# METRO E Line 1st Avenue SE & 2nd Street NE Station Location Discussion

E Line 1st Avenue & 2nd Street NE Platform Location - Station Neighbor Discussion

# Recommended Platform Location - proposed

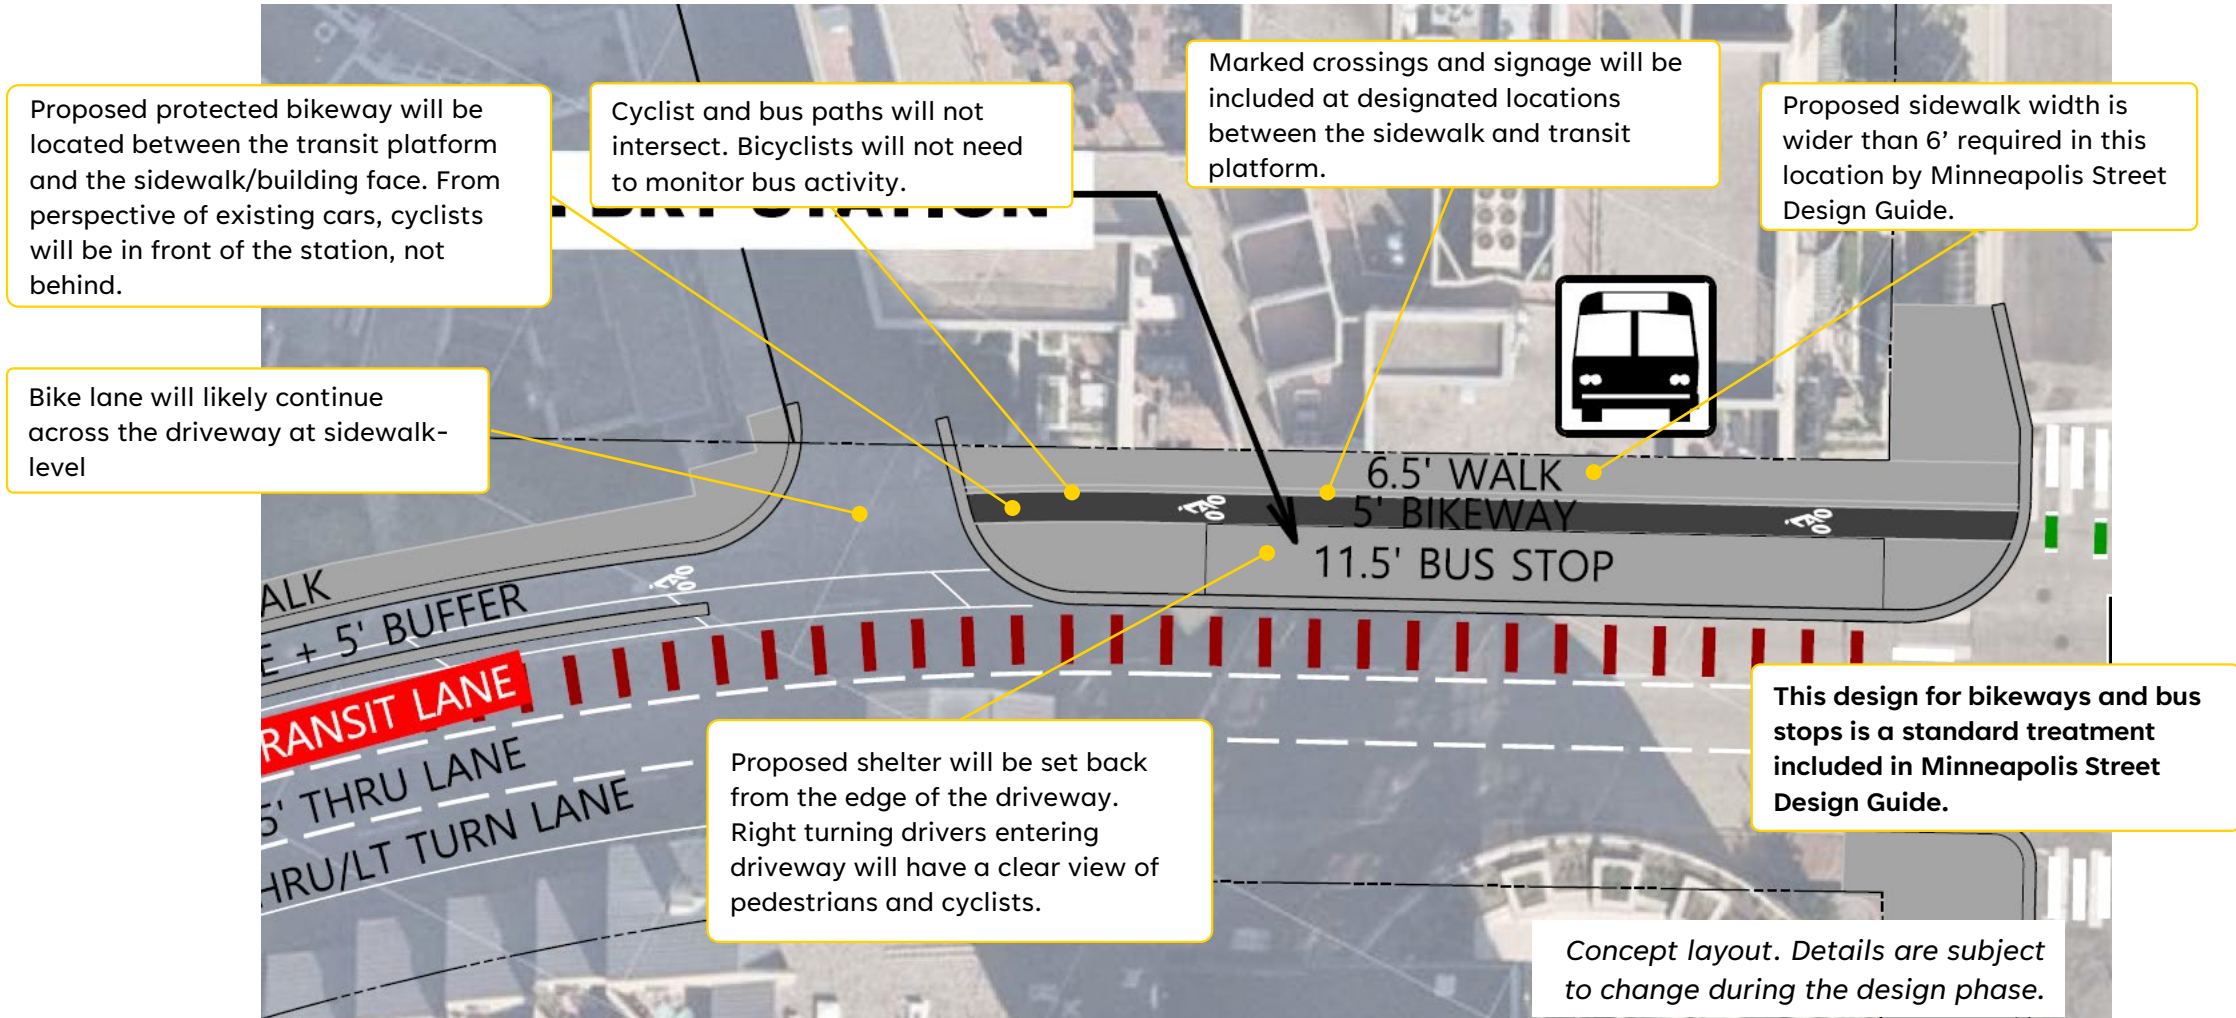
<u>Concern raised:</u>	<u>Response:</u>
<ul style="list-style-type: none"> <li>• There is very high pedestrian traffic along the south side of the 100 2nd St. NE building</li> </ul>	<ul style="list-style-type: none"> <li>• Pedestrian Counts show an average counts of about 20 pedestrians per hour with a maximum of 60 pedestrians per hour. The 6.5' sidewalk will adequately allow for pedestrians to traverse the sidewalk adjacent to the transit platform and bikeway.</li> </ul>
<ul style="list-style-type: none"> <li>• Bikers will be challenged to navigate while monitoring bus activity and additional pedestrian activity near the station.</li> </ul>	<ul style="list-style-type: none"> <li>• This design for bikeways / bus stops is a standard treatment included in the City of Minneapolis Street Design Guide.</li> <li>• Bicyclist and bus paths will not intersect in the proposed design. Bicyclists will not need to monitor bus activity but will need to pay attention for pedestrians and driveway users.</li> <li>• Like other transit platforms with protected bikeways behind, marked pedestrian crossings and signage will be included at designated pedestrian crossing locations between the sidewalk and the transit platform.</li> </ul>

<ul style="list-style-type: none"> <li>• A 6'5" sidewalk is not wide enough to safely protect pedestrians sandwiched between the bikeway and building</li> </ul>	<ul style="list-style-type: none"> <li>• Proposed 6.5' sidewalk width is wider than 6' required in this location in the Minneapolis Street Design Guide. 6.5' is comparable to existing pedestrian access route.</li> </ul>
<ul style="list-style-type: none"> <li>• Bikers will not be readily visible when exiting cars are looking through the station for oncoming traffic.</li> </ul>	<ul style="list-style-type: none"> <li>• Vehicles entering and exiting driveway will have to watch for cyclists on the bikeway. Shelter placement at this site will not interfere with visibility entering or existing the driveway.</li> <li>• Proposed protected bikeway will be located between the transit platform and the sidewalk and building face. From the perspective of exiting cars, bikers will be in front of the station.</li> <li>• The shelter will be set back from the edge of the driveway providing a clear view of the sidewalk and bikeway for right-turning vehicles into the driveway.</li> </ul>

# Residents entering and exiting driveway

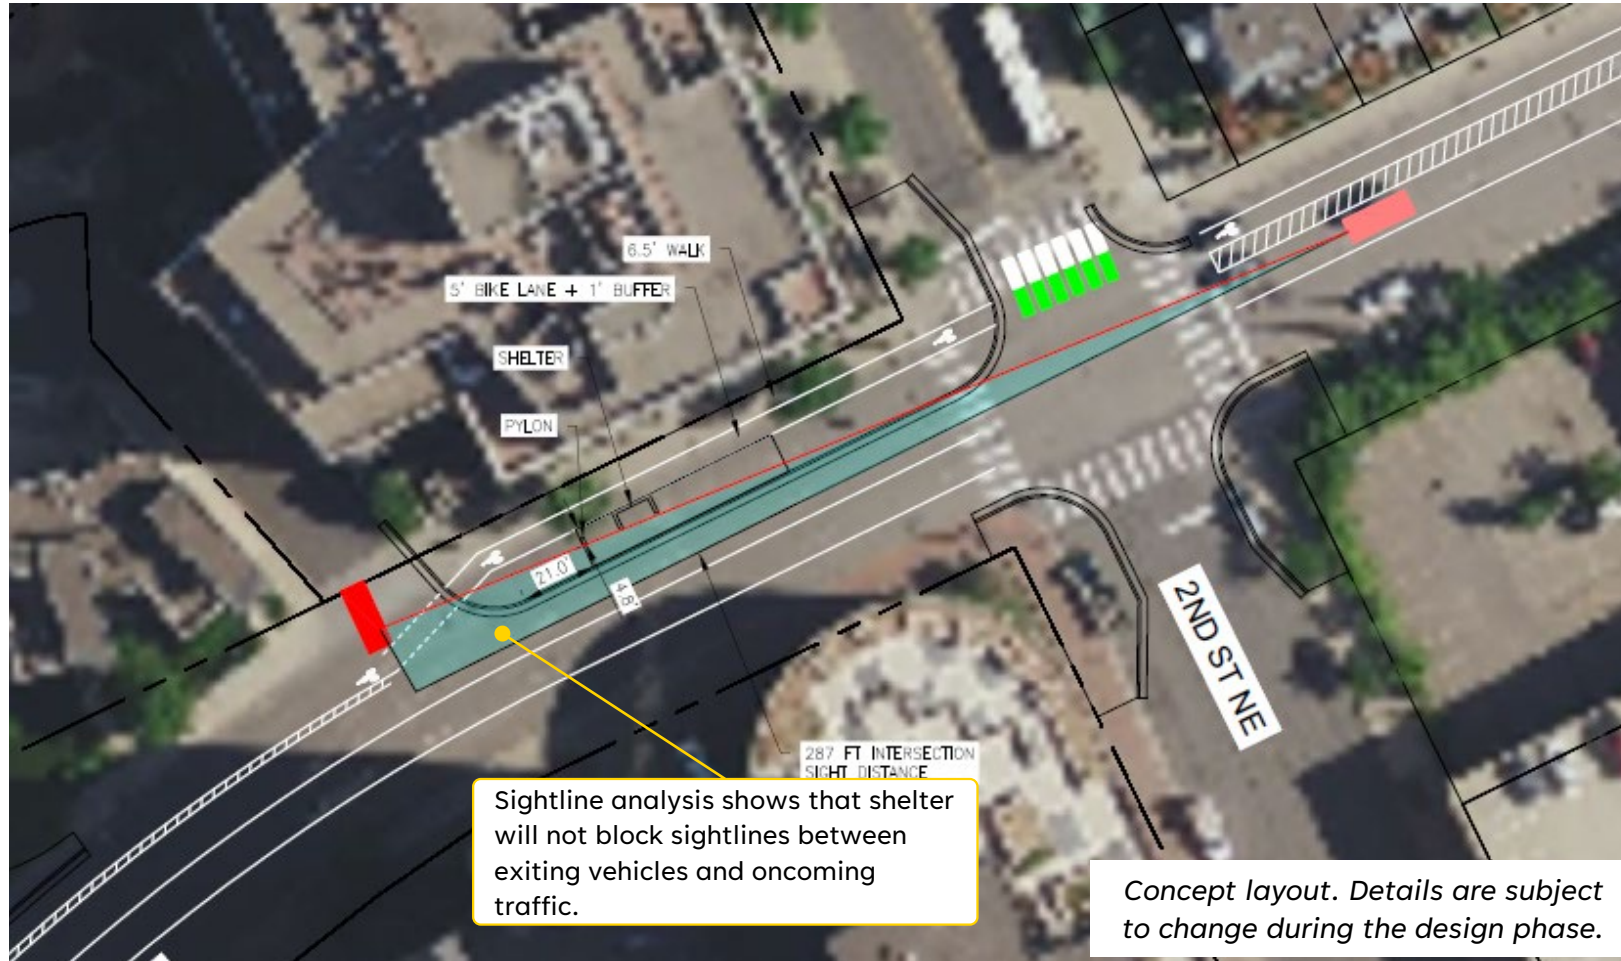
<u>Concern raised:</u>	<u>Response:</u>
<ul style="list-style-type: none"> <li>Hundreds of vehicles (Village Lofts and Village Brownstone) from the underground parking garage drive in and out each day. Adding a bus station would be extremely dangerous for the buses, residents, and pedestrians.</li> </ul>	<ul style="list-style-type: none"> <li>Similar to other driveways across the city, elsewhere there has been successful placement of transit stops, bikeways, and sidewalk facilities like proposed with this current planned station platform (examples to follow).</li> </ul>
<ul style="list-style-type: none"> <li>Sightline through a bus station for exiting cars will further challenge the safety of this driveway already challenged by pedestrians, bikers, runners, dog walkers and scooters.</li> </ul>	<ul style="list-style-type: none"> <li>Preliminary “sight triangle” analysis demonstrates that shelter will not block sightlines between exiting vehicles and oncoming traffic.</li> <li>If the County’s alternative 2 layout is selected, the rightmost lane will be limited to buses and right turning traffic only, significantly reducing the volume of vehicles using that lane</li> <li>Removal of space used for obstruction permit will remove the potential visual impact of large trucks and vehicles parked in lane for extended periods of time.</li> </ul>

<ul style="list-style-type: none"> <li>The average usage of this drive is over 517 vehicles / day.</li> </ul>	<ul style="list-style-type: none"> <li>Both local bus stops and BRT platforms are sited near driveways with comparable or higher average daily usage.</li> </ul>

# Fire safety/access and resident security

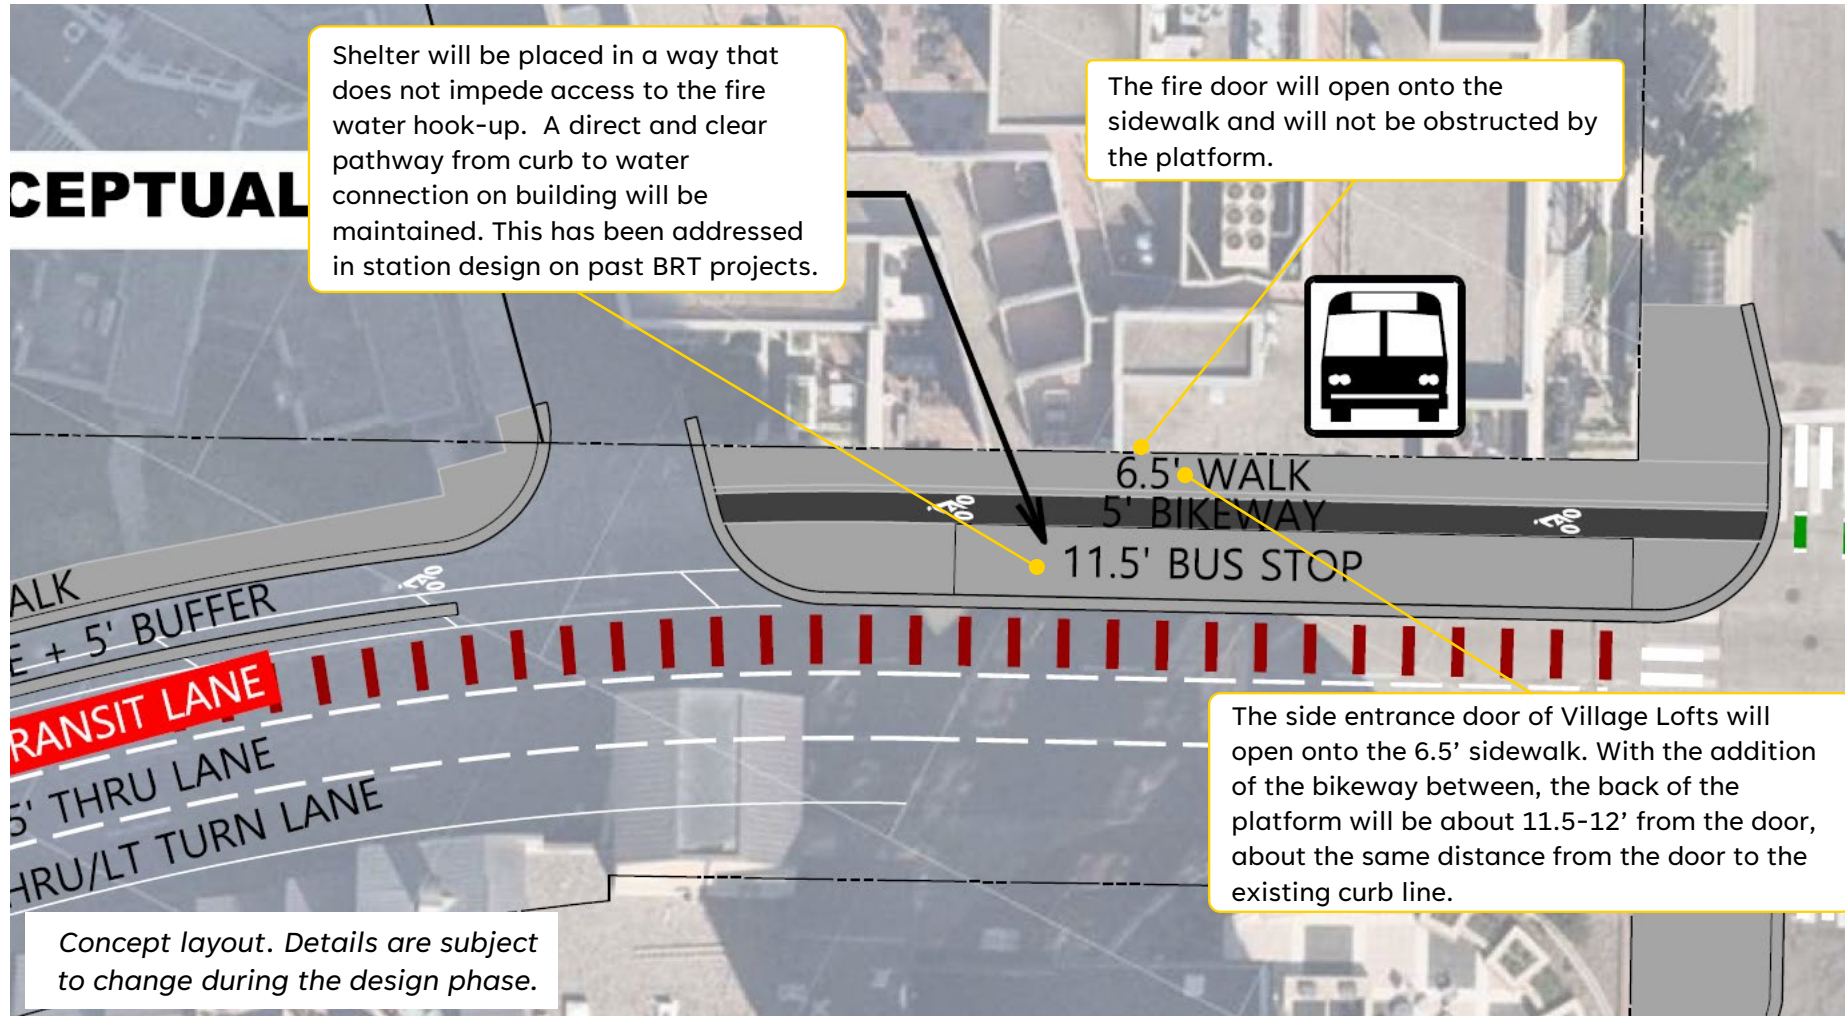
<u>Concern raised:</u>	<u>Response:</u>
<ul style="list-style-type: none"> <li>There is a fire exit door directly next to the proposed station that is a safety concern.</li> </ul>	<ul style="list-style-type: none"> <li>The fire door will open onto the sidewalk and will not be obstructed by the platform.</li> </ul>
<ul style="list-style-type: none"> <li>The busy bus station may impede access for fire trucks to access the fire water hook-ups from our building behind the proposed station.</li> </ul>	<ul style="list-style-type: none"> <li>Shelter will not be placed in a way that impedes access to the fire water hook-up. This has been addressed in station design on past BRT projects.</li> <li>Professionally trained bus operators, like other vehicles, yield to and move out of the way of emergency vehicles and will not obstruct fire access to the building.</li> </ul>
<ul style="list-style-type: none"> <li>Our side entrance door of Village Lofts opens directly onto the platform. Residents will have less open space to enter and exit and an increase of individuals trespassing, and a place hidden from public view.</li> </ul>	<ul style="list-style-type: none"> <li>The side entrance door of Village Lofts will open onto the 6.5' sidewalk. With the addition of the bikeway between, the back of the platform will be about 11.5-12' from the door, about the same distance from the door to the existing curb line.</li> <li>All BRT stations are equipped with standard safety features including pedestrian-scale lighting within the shelter and along the platform, monitored security cameras, and emergency telephones. Clear glass allows for views into and out of the shelters.</li> </ul>

# Village Lofts delivery

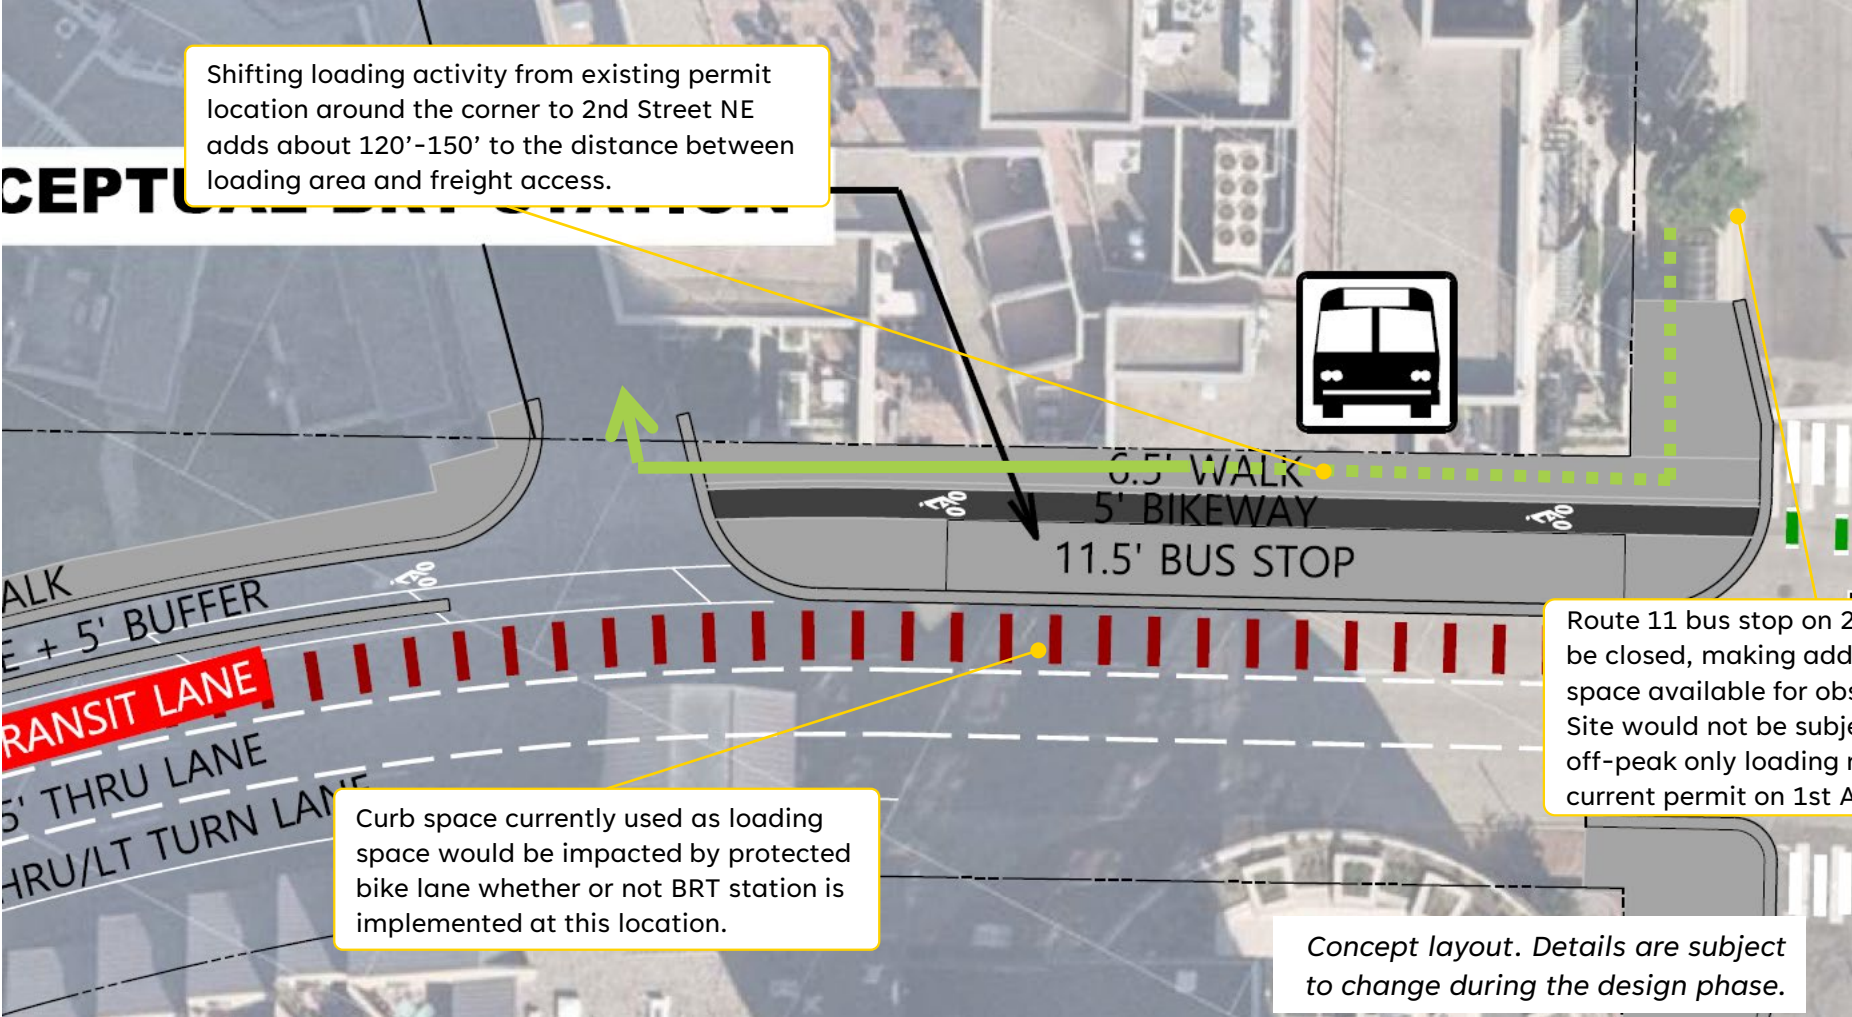
<u>Concern raised:</u>	<u>Response:</u>
<ul style="list-style-type: none"> <li>The proposed BRT station would relocate our commercial loading space, which is currently a city-approved encroachment permit (part of the original approval by the City of Minneapolis).</li> </ul>	<ul style="list-style-type: none"> <li>Curb space currently used as loading space would be impacted whether or not BRT station is implemented at this location, obstruction permit will not continue under any roadway scenario.</li> <li>City evaluates application and issues an obstruction permit on annual basis and is not guaranteed into perpetuity.</li> <li>Loading zone is not a city-approved encroachment space and loading zones of any type are not approved through the site plan process.</li> <li>Route 11 bus stop on 2nd Street NE will be closed, making additional curb space available for obstruction permit (City ROW office sees no reason why this wouldn't be granted)</li> <li>This site would not be subject to the same off-peak hour restrictions as the permit currently granted on 1st Avenue, extending the potential loading hours for the building.</li> </ul>

<ul style="list-style-type: none"> <li>All building services and oversized deliveries will need to be walked around the block, past the proposed platform and down the resident driveway in order to access the resident garage.</li> </ul>	<ul style="list-style-type: none"> <li>Shifting loading activity from existing permit location around the corner to 2nd Street NE adds about 120'-150' to the distance between loading area and freight access.</li> <li>Loading distance is comparable to other residential and commercial loading zones within City of Minneapolis.</li> </ul>
